ISLANDER ENGINEERING

Memorandum

Project: 2181

Re: **Environmental Monitoring Inspection (May 10, 2021) at 4415 Bedwell Harbour Road, North Pender Island BC**

Photo 9 – Spill response plans posted within hydrocarbon storage container. Emergency contact information is provided below posted signs.

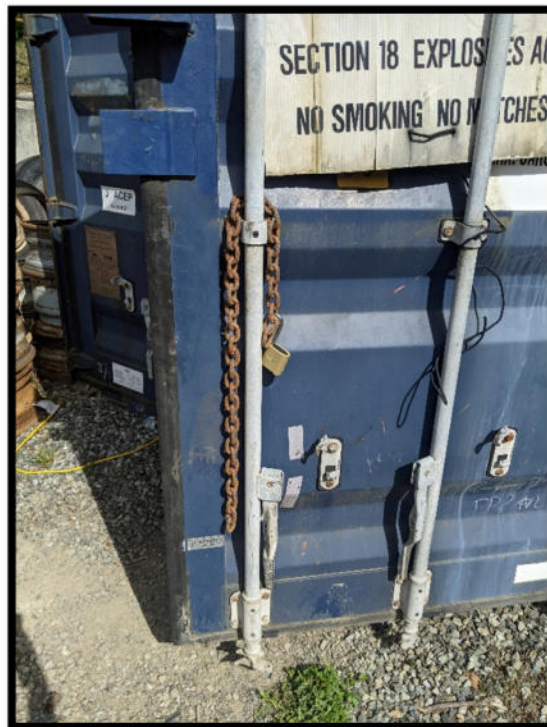
- Spill Response Steps posted in appropriate areas	Yes	Within mechanical fluid shed and additive shed. (Photo 9)
7.2 Spill Response Equipment		
- Standard Spill Kit	Yes	Spill kits are located within the mechanical fluid shed, the additive shed, the batching area and within all active vehicles. (Photo 17)

Photo 32 – Waste water retention area. Steel tanks were full of concrete solids at the time of inspection, so the lined secondary containment area, seen here, was in use to store waste waters.

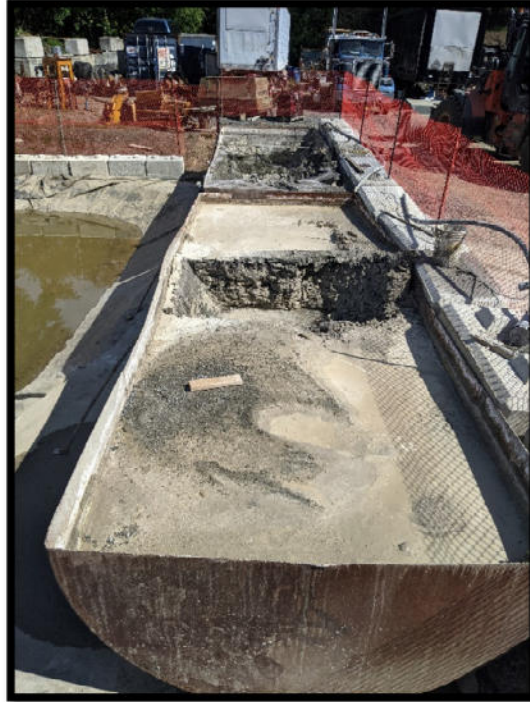
<p>should be minimized through batching area where wastewater may be present;</p>		<p>back in, are filled with concrete and then pull out in the forward direction. This configuration discourages any other vehicular traffic from entering the area. No other equipment is stored within the bay.</p>
<p>- Sufficient capacity must be provided for wastewater holding tanks / basins;</p>	<p>Yes</p>	<p>Water is circulated throughout the closed system to allow for additional capacity as needed. Additional basins have been added that can act as additional storage volume. (Photos 20-22, 32 & 33)</p>
<p>- Wastewater holding tanks / basin shall be impermeable;</p>	<p>Yes</p>	<p>45 mil poly liners are present within all wastewater basins. Primary wastewater basin is a steel drum that is located within a poly lined cell (Photo 32 & 33)</p>
<p>- Sufficient secondary containment (i.e., berms) shall be provided to capture any overflow from wastewater holding facilities.</p>	<p>Yes</p>	<p>At the time of inspection, the secondary containment area was temporarily being used as the primary holding area to allow for cleaning of the primary holding area. (Photo 32 & 33)</p>
